SERVICE BULLETIN #126

04/25/14

9661 Spoke Wheel

Obsolete Part

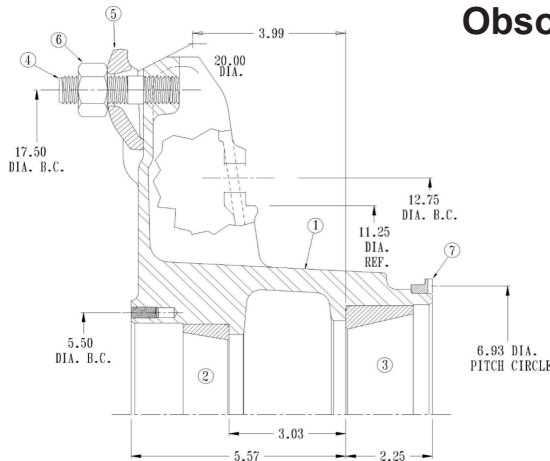
Upon depletion of inventory, the 9661 spoke will become obsolete with no direct replacement. We do however recommend a replacement: the 10-stud 2530 hub. This requires changing brake drums, changing to a disc hub, and changing to disc wheels instead of demountable rims. If you have any questions, please contact the Webb Engineering department via email to engineering@webbwheel.com or call 256-736-6356.
